HEARINGS OFFICER HEARING - LAND USE: THORNBURGH SITE PLAN

FILE NUMBER: 247-21-001111-SP

PROPOSAL: Site Plan review for 70 Overnight Lodging Units (OLUs) in the Thornburgh Destination Resort.

*Figure 7 – FMP Master Development Plan Visitor Lodging Location
(Reference Orange Areas inside Bubbled Area)*

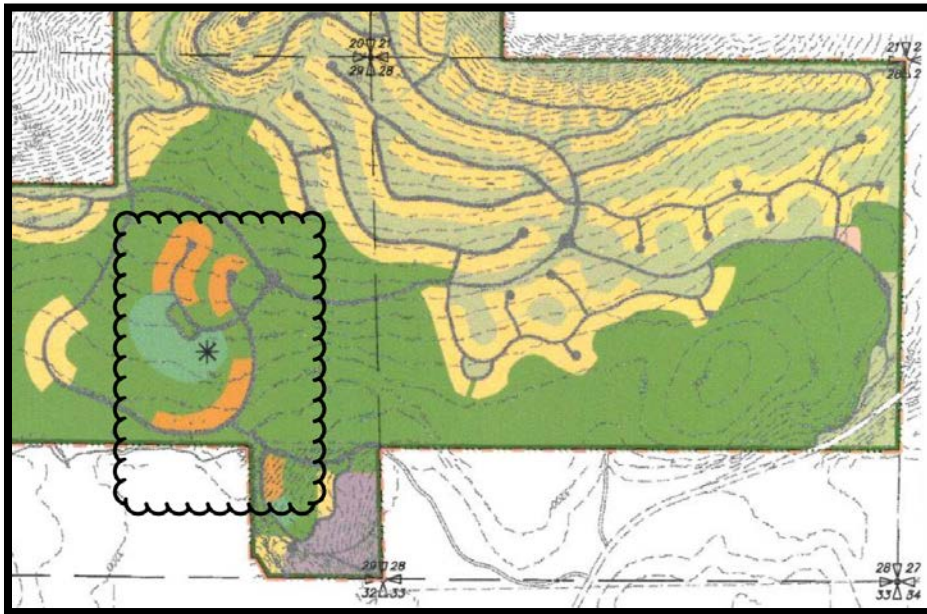
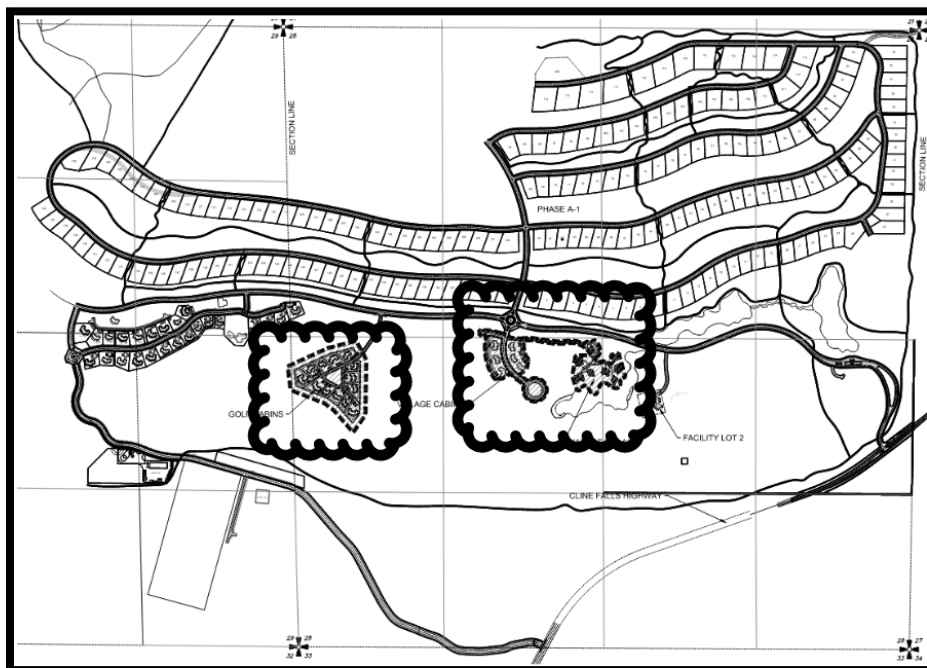
Based on this response, staff understands the applicant's current proposal is limited to site plan

approval for 70 OLUs in the general location allowed by the FMP Master Development Plan with no proposed changes to the FMP. As shown in *Figure 7* below, the FMP Master Development Plan identifies the general location of the required visitor lodging. The approved visitor lodging is located in Section 29 of Township 15S, Region 12E. However, the proposed OLUs will be located in Section 28 of Township 15S, Region 12E (see *Figure 8* below). For this reason, staff asks the Hearings Officer to determine if the proposed location complies with the FMP Condition 1.

Figure 9 - Proposed Parking Location for Nature Villa OLUs

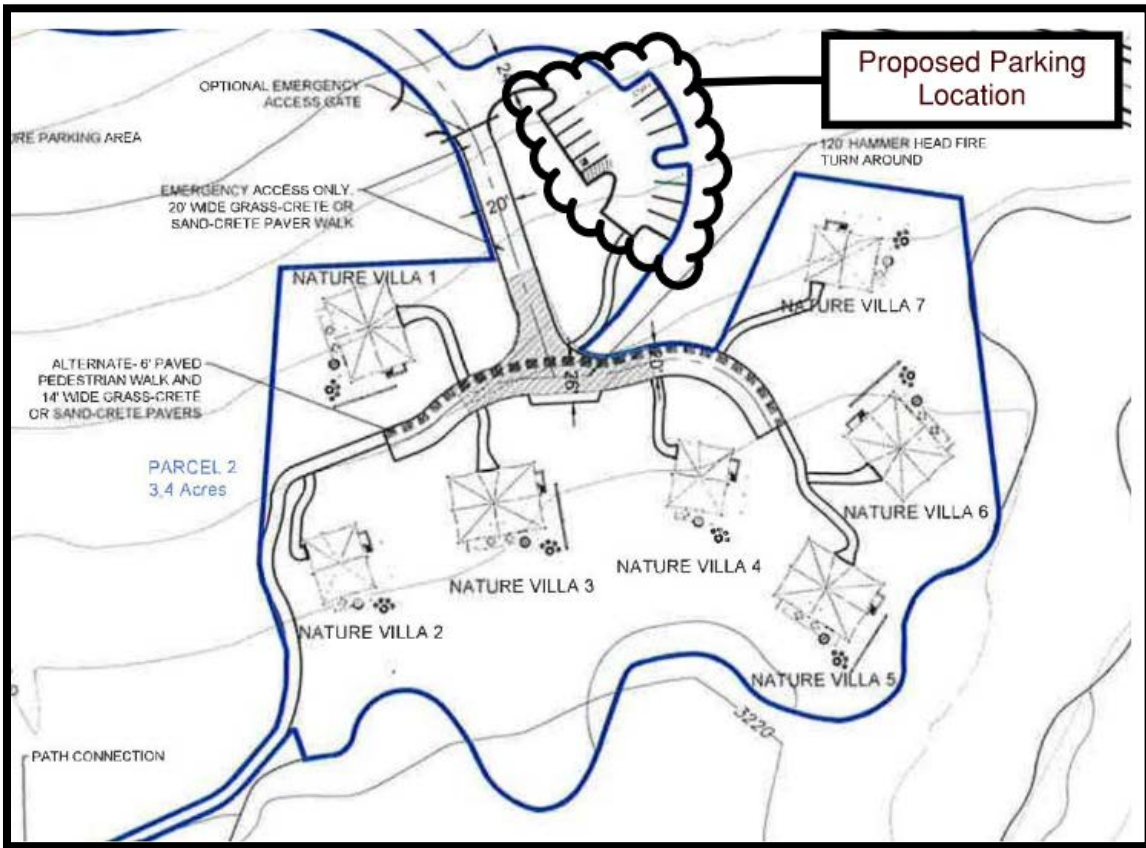
Staff finds the proposed parking spaces for the Nature Villa OLUs are not adjacent to each OLU structure (see *Figure 9* below). The Applicant's incomplete letter response, dated March 1, 2022, appears to acknowledge this discrepancy with the following response:

Staff asks the Hearings Officer to make specific findings on whether all of the requirements of FMP Condition 33 are met.

Figure 10 – FMP Open Space Plan (Exhibit A.1.1)

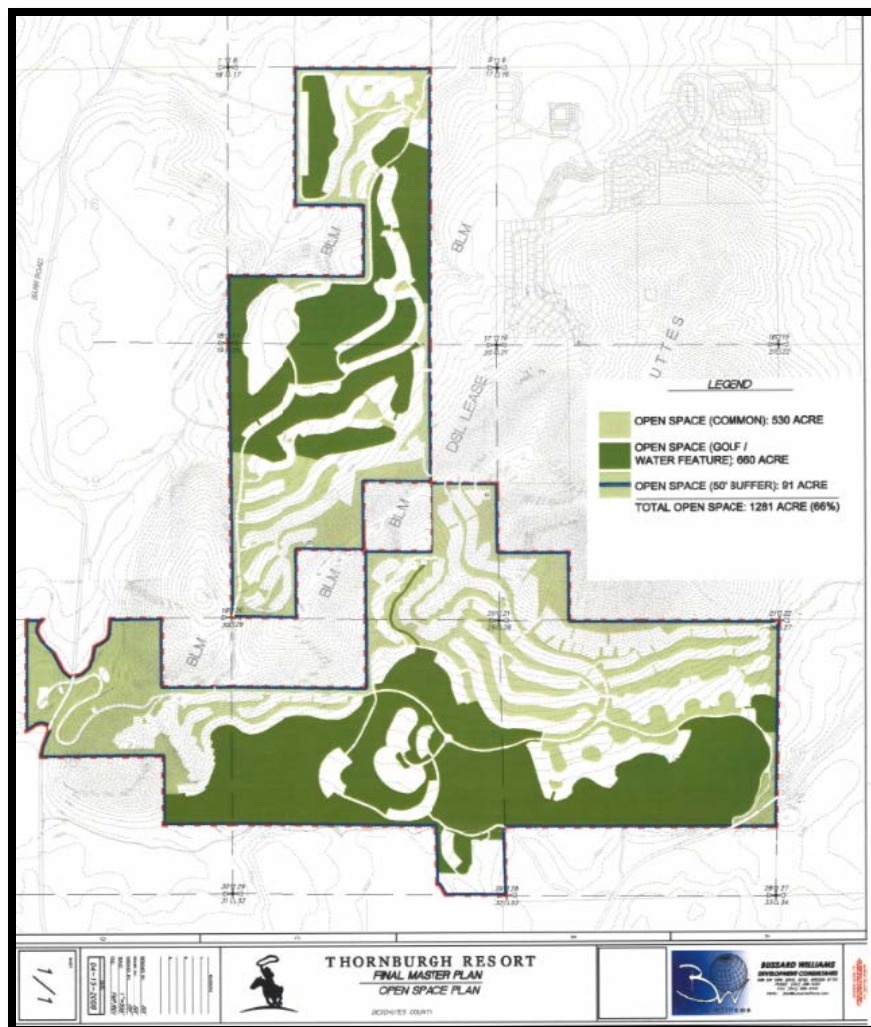
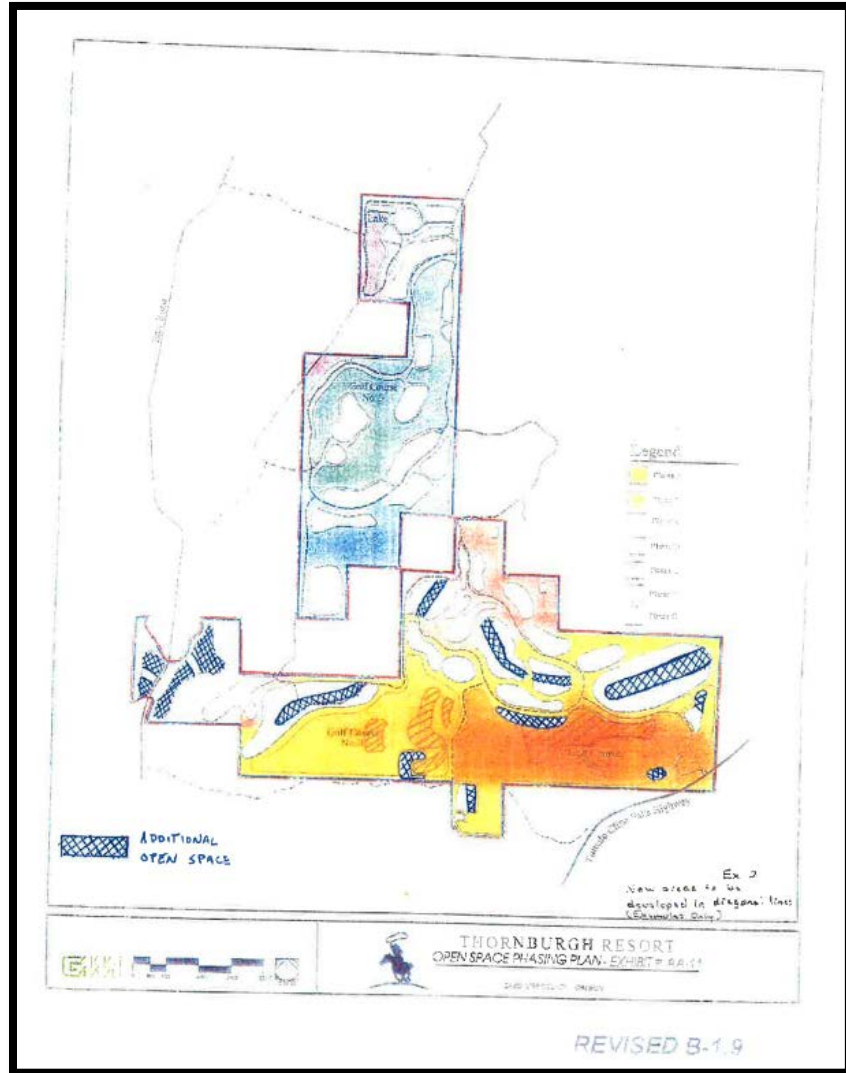
Figure 10 and Figure 11 below show the open space areas approved as part of the FMP. The proposed OLU site plans appear to be located in areas identified as open space areas on these maps. Staff recommends a condition of approval to ensure compliance.

Open Space Area Restoration. Where construction disturbs native vegetation in open space areas that are to be retained in substantially natural condition, Applicant shall restore the native vegetation. This requirement shall not apply to land that is improved for recreational uses, such as golf courses, hiking or nature trails or equestrian or bicycle paths.

Figure 14 -Village Cabin Overflow Parking Spaces

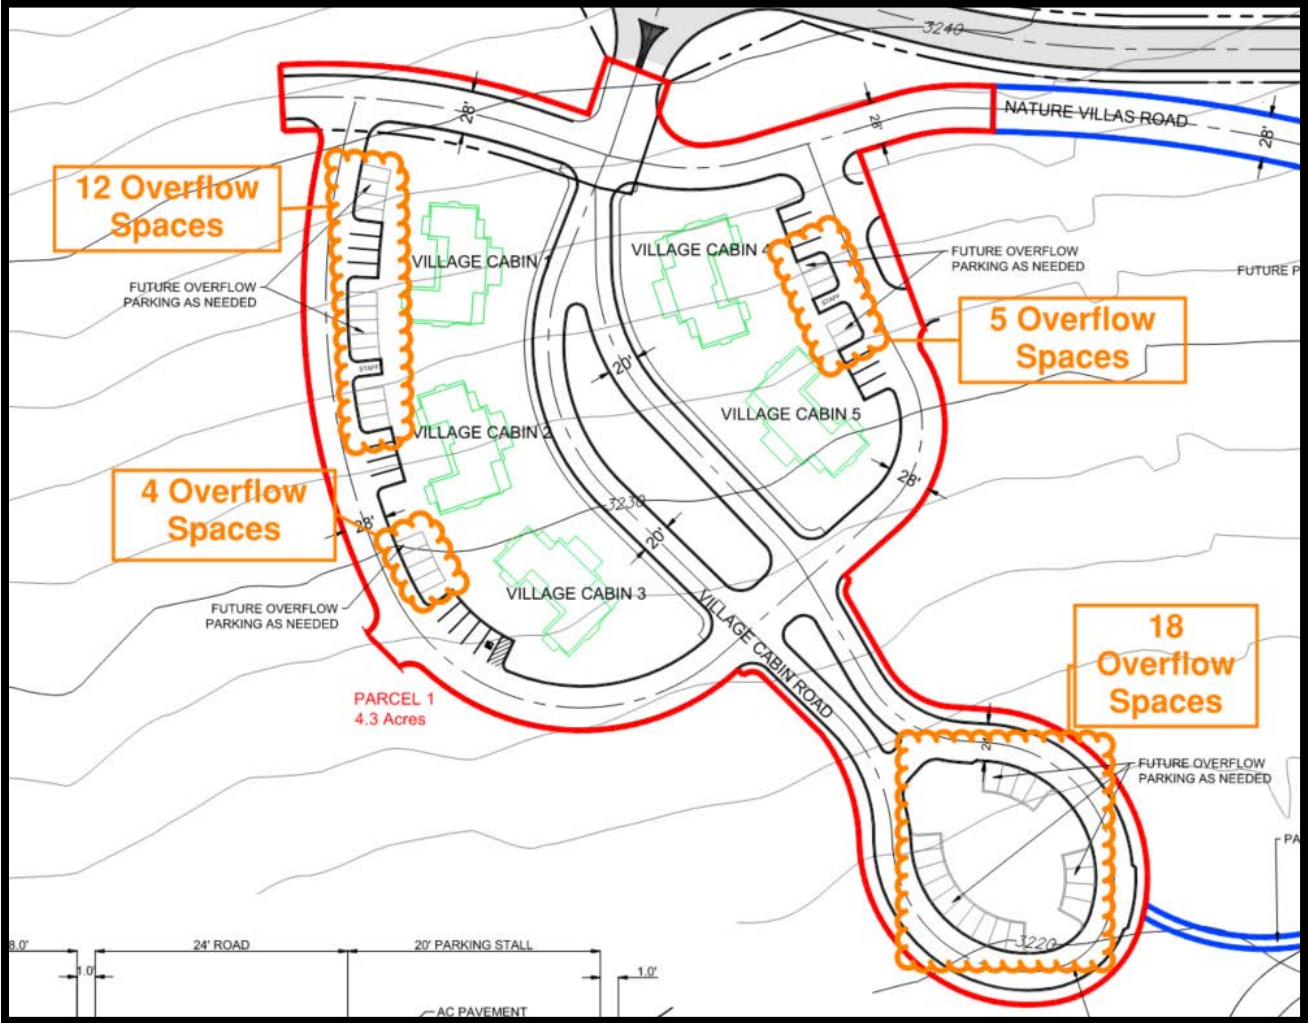
In addition to the required parking, it appears the applicant may be requesting approval for several

overflow parking areas for the Village Cabin OLU use. The submitted site plan shows a total of 39 overflow parking spaces (see Figure 14 below). Staff notes no explanation was provided by the Applicant regarding why this amount of overflow parking is necessary for the Village Cabin OLU, but not the other proposed OLU. For this reason, it is unclear if these parking spaces are intended to be used in association with other, future, uses of the resort. Staff asks the Hearings Officer to make specific findings on what parking spaces are included in this review.

Figure 15 - Distance of Southern Overflow Parking from Closest OLUs

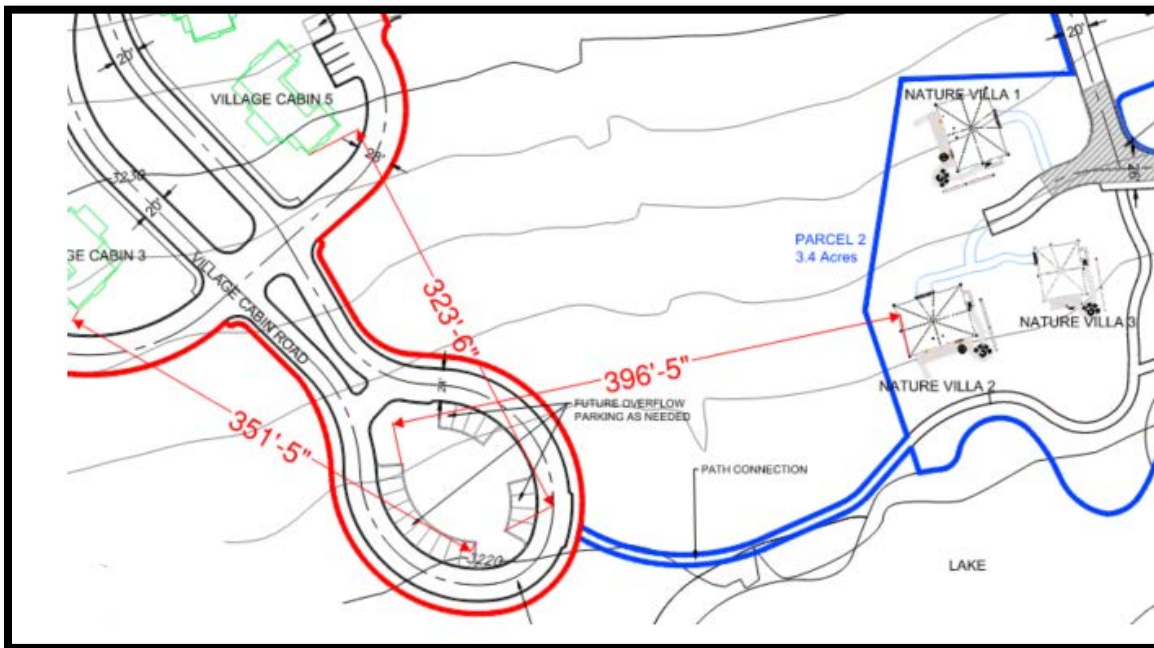
Based on this response, it appears the Applicant plans to submit future Site Plan review applications for other facilities located in the Village Cabin area. Based on this response, staff finds no joint use parking is proposed at this time.

Figure 17 – Nature Villa Single OLU Bicycle Parking Location

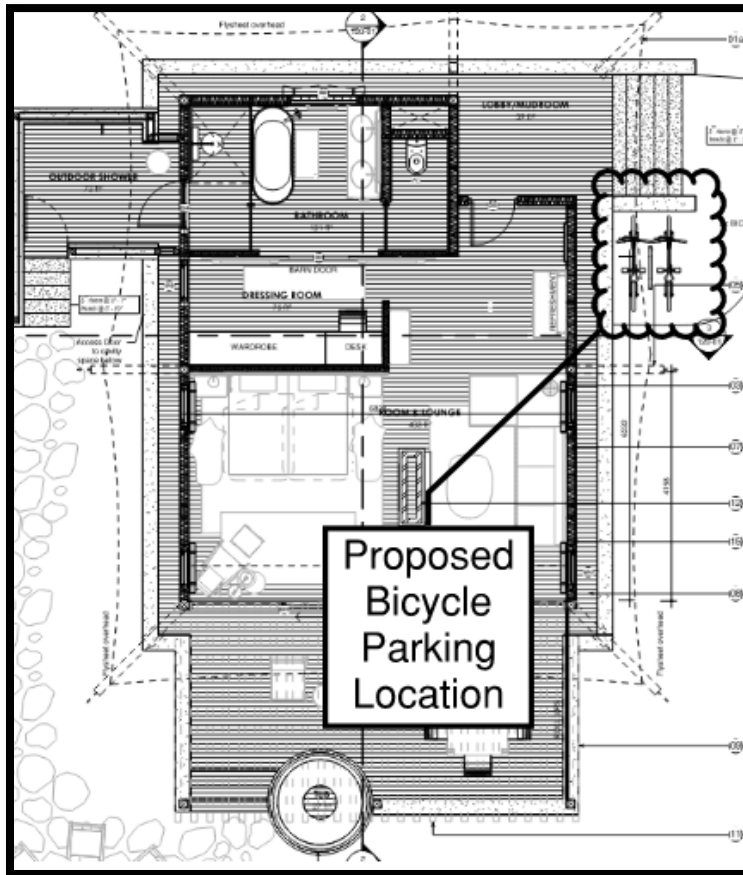
FINDING: Staff finds the proposed sheltered bicycle parking shown on sheets BP-11 and BP-13 do not comply with these criteria (see Figure 17 and Figure 17 below). The reference drawings shows this parking is only partially under a “decorative PVC flysheet”. Additionally, staff finds the proposed sheltered bicycle parking shown on sheets BP-1 and BP-9 are not fully covered. Staff asks the Hearings Officer to verify if the proposed bicycle parking complies with these criteria.

Figure 19 - Phase A-1 Tentative Plan Drawing

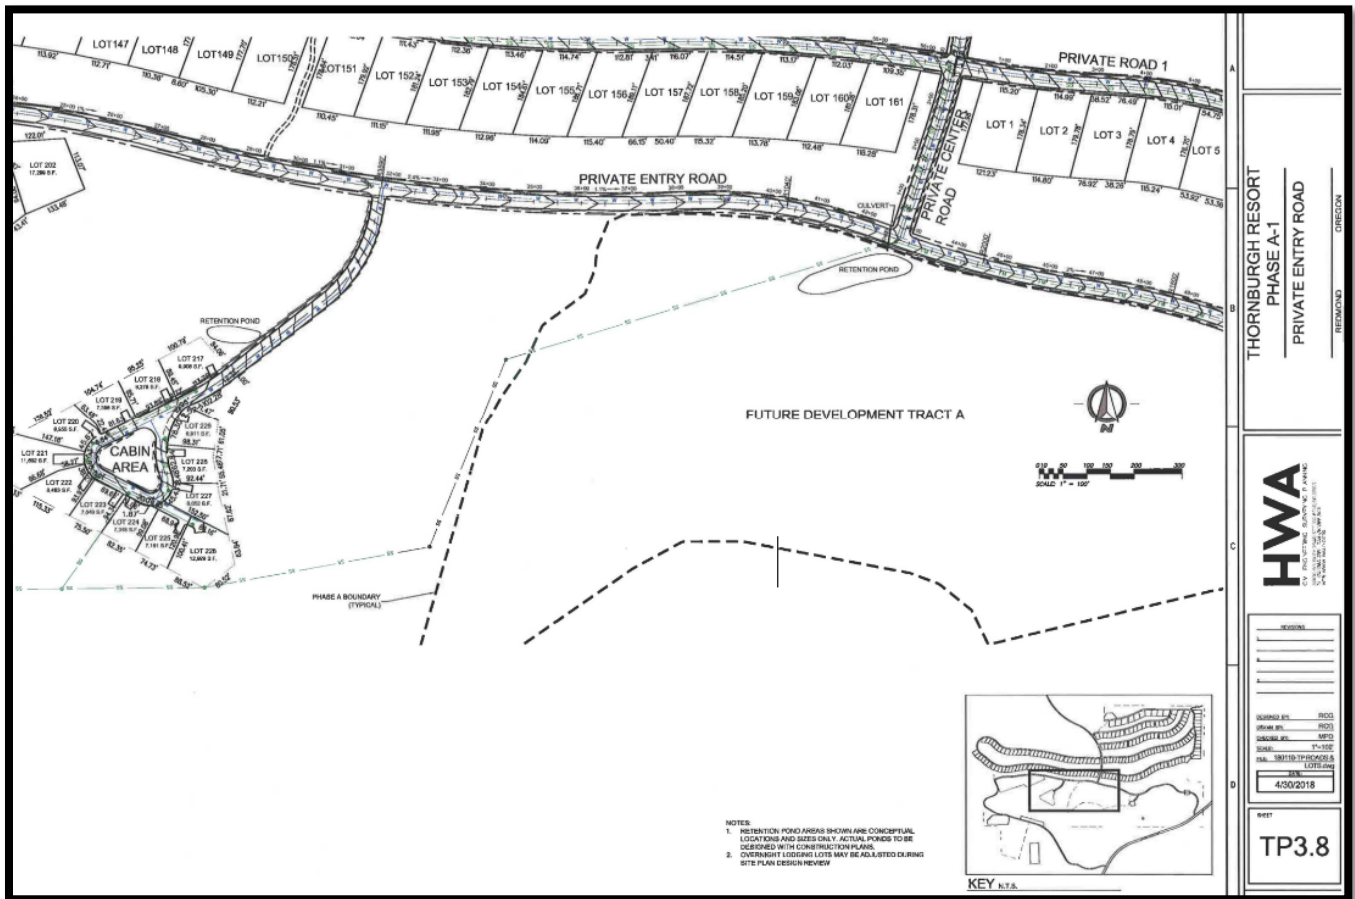
Staff finds only the access point and street layout for the proposed Golf Course Cabin OLUs was evaluated under the Phase A-1 Tentative Plan approval. As shown in Figure 19 below, the proposed development area for the Village Cabin OLUs and Nature Villa OLUs is identified as a "Future Development Tract A" and this figure clearly shows this area is not located within the "Phase A Boundary".

Staff finds the proposed roads and alleys shown on the Village Cabin OLUs and Nature Villa OLUs have not been reviewed as part of a Tentative Plat approval. Therefore, it is unclear to staff if the proposed roads and alley meet all of the applicable design requirements of DCC Title 17. Additionally, it does not appear the proposed alley access to Golf Cabin Lots 224-227 has been approved by the County.

The Applicant's proposal shows Village Cabin Road will extend more than 300 feet beyond the location of the proposed OLUs. Staff finds this proposed street segment is not necessary to serve the proposed OLUs and will disturb additional native vegetation on the site. Staff notes Sheet C6.0 shows the proposed road network adjacent to the proposed Village Cabin OLUs has the necessary

Figure 20 – Phase A-2 Tentative Plan Drawing

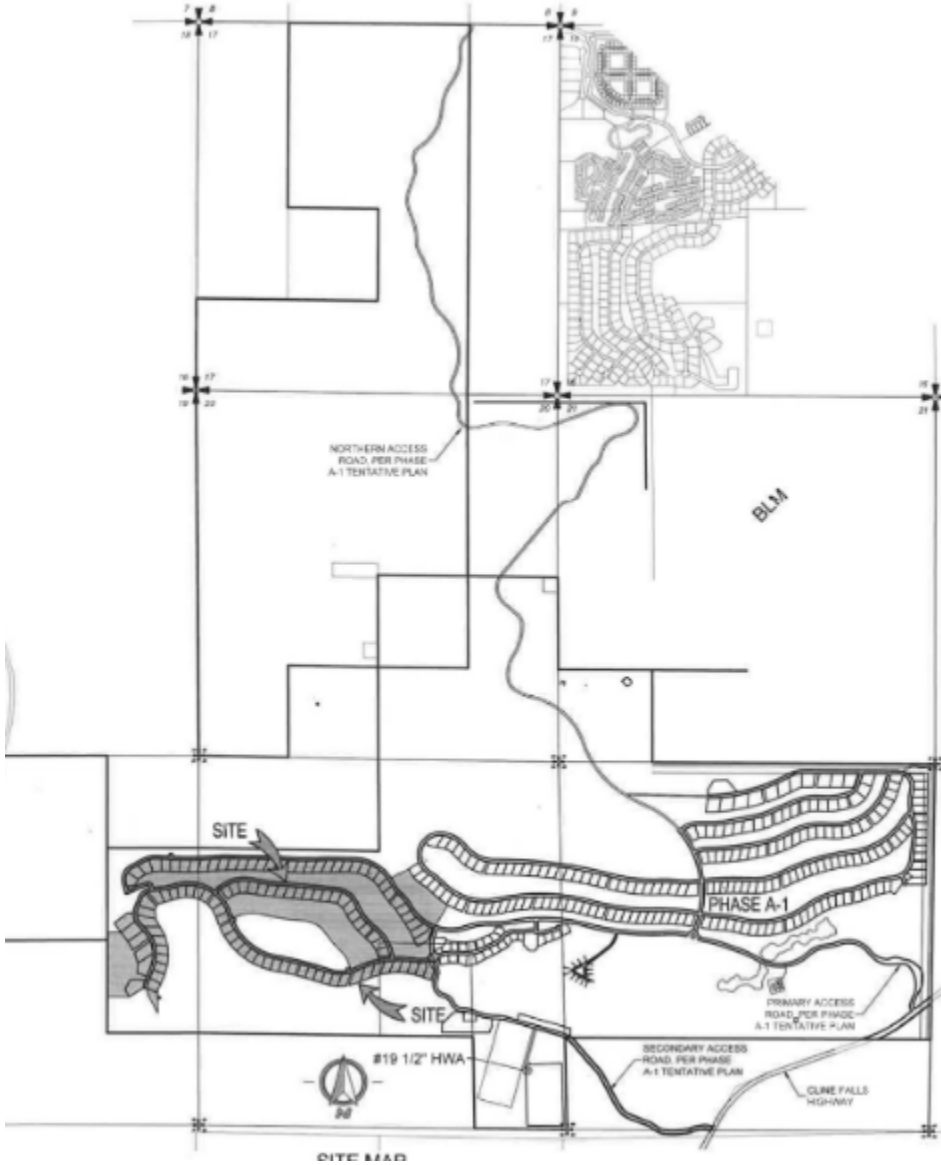
Staff finds the roads serving the Golf Cabins OLUs were reviewed under Tentative Plan A-1. However, the A-2 Tentative Plan approval did not include any areas within the proposed OLU development areas and the relevance of this review, as part of the current proposal, is unclear (see Figure 20 below). Staff finds the proposed Village Cabin Road and Nature Villas Road have not been

reviewed as part of a Tentative Plan approval and do not appear to be laid out as shown on the FMP Master Development Plan. For these reasons, staff believes the applicant has not obtained the necessary approvals from the County to establish these roads as the County has not been afforded an opportunity to review and identify required sight distance, turn and acceleration/deceleration lanes, right-of-way, roadway surfacing and widening, or bicycle and pedestrian connections. Staff asks the Hearings Officer to make specific findings on this issue.
